Docket Number:	22-BSTD-01
Project Title:	2025 Energy Code Pre-Rulemaking
TN #:	252177
Document Title:	Pool & Hot Tub Alliance and CA Swimming Pool Association Comments
Description:	N/A
Filer:	System
Organization:	Pool & Hot Tub Alliance and CA Swimming Pool Association
Submitter Role:	Public
Submission Date:	9/7/2023 3:21:35 PM
Docketed Date:	9/7/2023

PHTA CPSA Comments

Re: Proposed updates to the CA Energy Code related to pool and spa heating

Typical Solar collector plumbing kit available in market

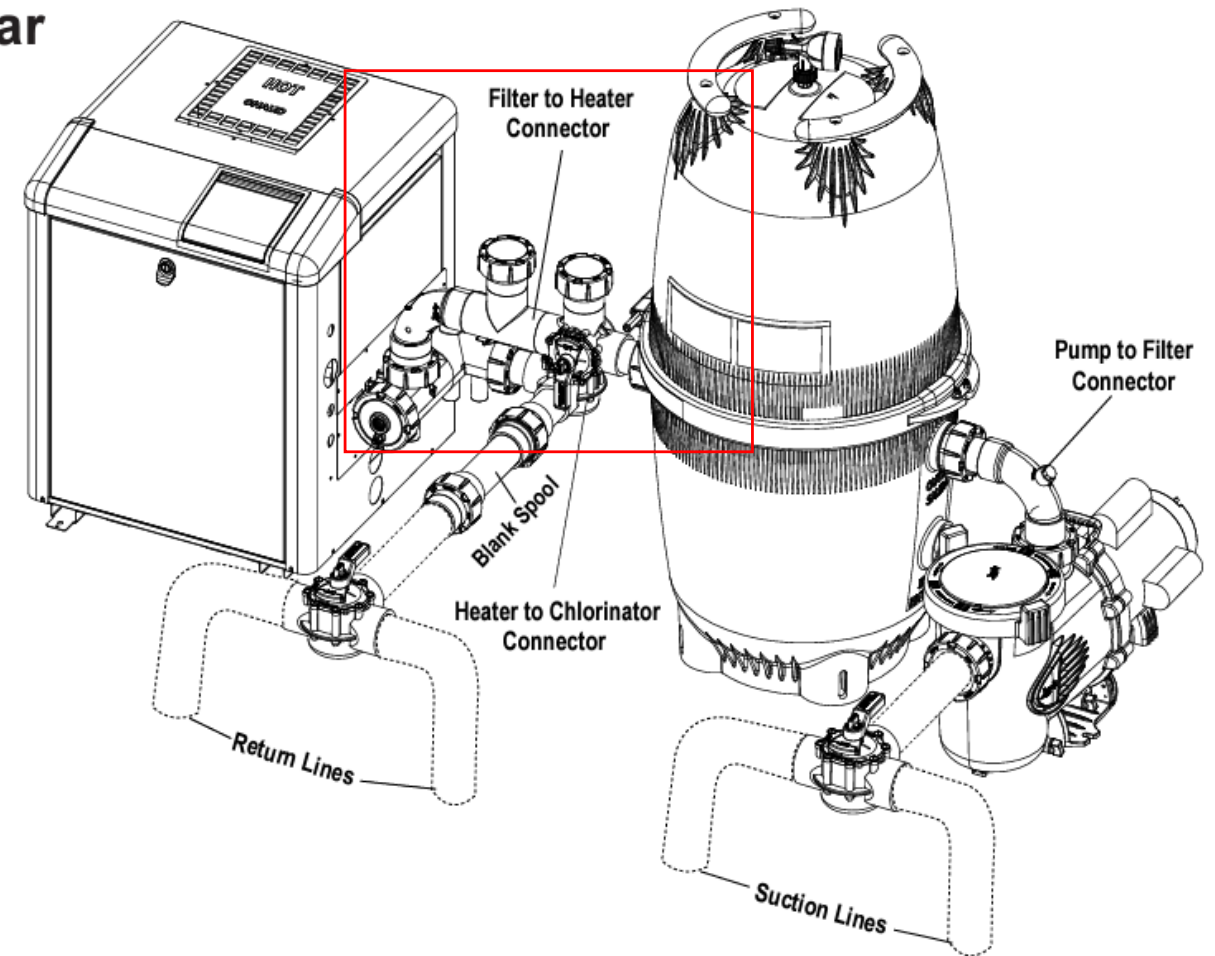
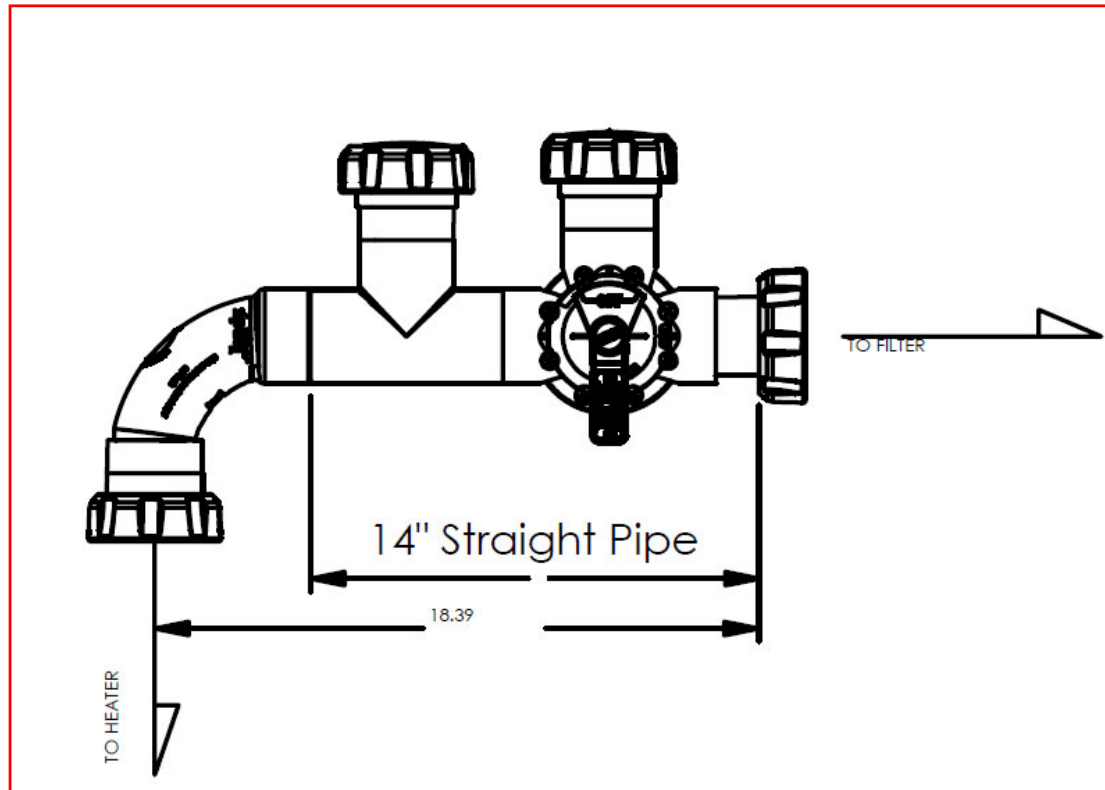
Reasoning: PHTA and CPSA urge the Commission to follow the ANSI/PHTA/ICC-15 Standard that has been adopted in countless states and local jurisdictions via adoption of either the International Energy & Conservation Code (IECC) or International Swimming Pool & Spa Code (ISPSC), or direct state code references such as the Florida Energy Code. This standard requires a minimum of 18 inches and although the standard applies to residential pools, there is no difference in commercial versus residential application when adding piping for the future installation of solar heating. Simply put, 18 inches is sufficient in either case.

The 18 inches of horizontal or vertical pipe is more than enough room to provide two Ls and a T with a valve. In addition, 36 inches could not work in some spaces, as there are cases where not enough room will exist on the pool pad or equipment room. In canvassing our members and solar representatives, no one has said 18 inches of pipe for a solar pool heating installation is not adequate. Please also see the drawing of a typical solar piping kit that is available on the market, along with a photo of an install using 2.5" plumbing (attached to submittal). These kits are available with all pre-cut components that then get assembled in the field, using the 18-inch minimum requirement. If these 18-inch kits were not adequate in some instances, installers would let kit manufacturers know. The fact is they do work and we encourage the Commission to align with what is both on the market and in national codes and standards.

- Jandy VPK-CVSLR
- Accommodates 2" and 2-1/2" plumbing.
- 14" Straight pipe requirement

Installed Solar Plumbing Kit Using 2-1/2" Pipe

- (b)2. Piping.** At least ~~18~~³⁶ inches of horizontal or vertical pipe shall be installed between the filter and the heater or dedicated suction and return lines, or built-in or
